Work Order ID 161281

DRAWING NO. D3394	TITLE LUG	REV. B	DART AEROSPACE LTD ENGINEERING ORDER		D.E.O. NO. D3394-B-1	SHEET NO. SHEET 1 OF 1	SCALE NTS
DRAWN AJS	CHECKED	MFG. APPR.	APPROVED		DE APPR.		
DATE 09.11.04	DATE 09.11.04	DATE 09.11.04	DATE 09/11/04		DATE 09/11/04

DRAWING NO. D3394	TITLE LUG	REV. B	DART AEROSPACE USA, INC ENGINEERING ORDER		D.E.O. NO. D3394-B-2	SHEET NO. SHEET 1 OF 1	SCALE NTS
DRAWN DP	CHECKED SC	MFG. APPR. M	APPROVED MP		DE APPR. H		
DATE 11.05.02	DATE 11.05.09	DATE 11.05.09	DATE 11.05.09		DATE 11.05.09

SECTION A-A

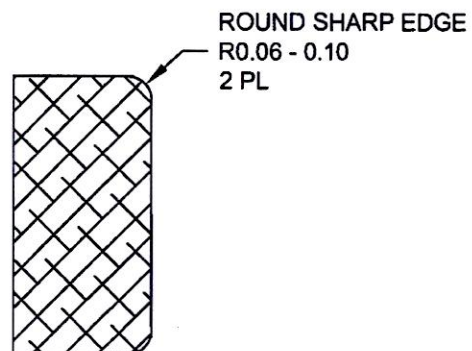
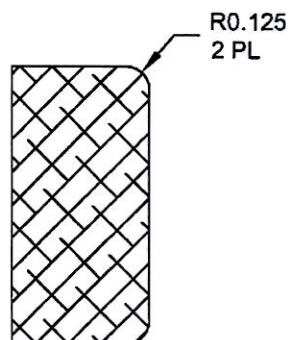
SHEET 4 ZONE A,1 MODIFY SECTION A-A AS SHOWN:

REASON: DRAFTING ERROR

IS:

D3394-1RG LUG (SHOWN)
D3394-3RG/-5RG LUGS (SIMILAR)
D3394-041RG/-043RG/-045RG LUG ASSEMBLIES (SIMILAR)

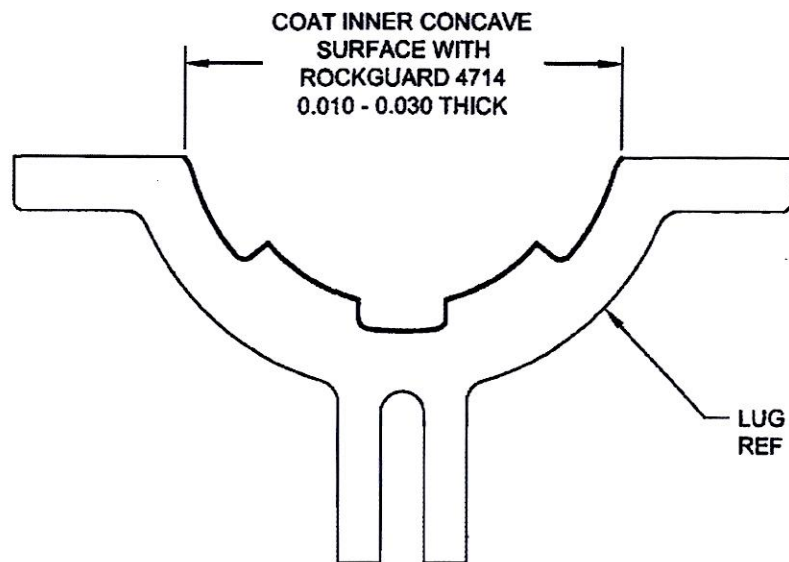
ADD D3394-xRG OPTION

D3394-xRG MOUNTING LUGS ARE IDENTICAL TO D3394-x MOUNTING LUGS, HOWEVER AFTER FINISH, COAT INNER CONCAVE SURFACE WITH "PLUS ONE ROCKGUARD 4714" AS SHOWN BELOW.
